CBF240037 –

Change from Speedcon (SCO) to M12x1 full-thread

The SAC and SACC articles listed in the Product Change Notification currently feature the Speedcon (SCO) fast-locking thread, which allows the M12 connector head to be connected with only a half turn.
These articles will be changed to the M12x1 full-thread connection.

Change of the thread

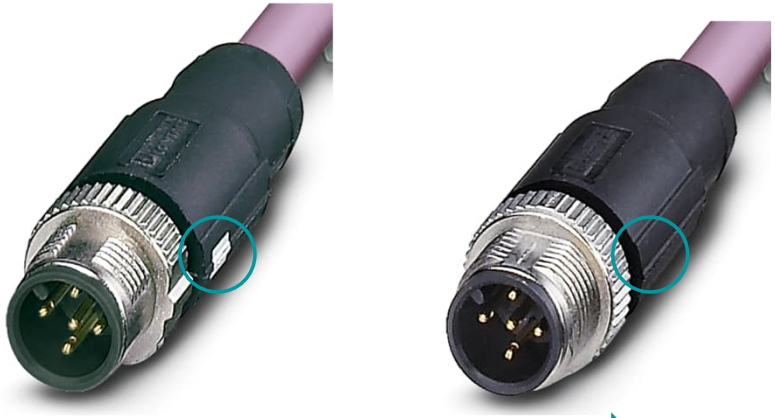
From SCO to M12x1 full-thread

Change of the marking

From marked to unmarked
